Subject: Structural Framing Evaluation

Location: 195 High Meadow Drive (Angier, NC)

Project No: RSF140316 Inspection Date: 5/21/2014

REPAIR DETAIL

F07-R

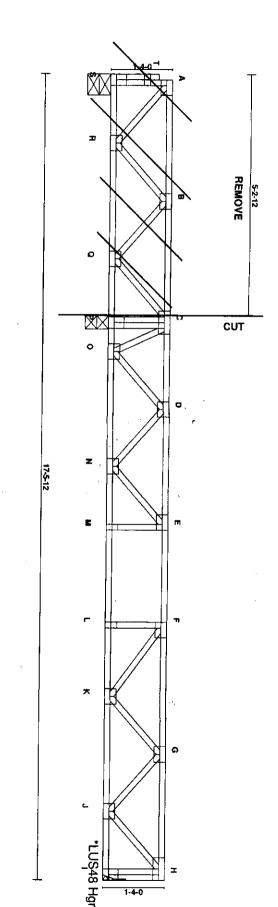
REPAIR - TO CUT-OFF LEFT SPAN OF TRUSS:...

CUT CLEANLY THRU LUMBER/PLATES ADJACENT TO INTERIOR BEARING.

NO FURTHER REPAIRS NEEDED.
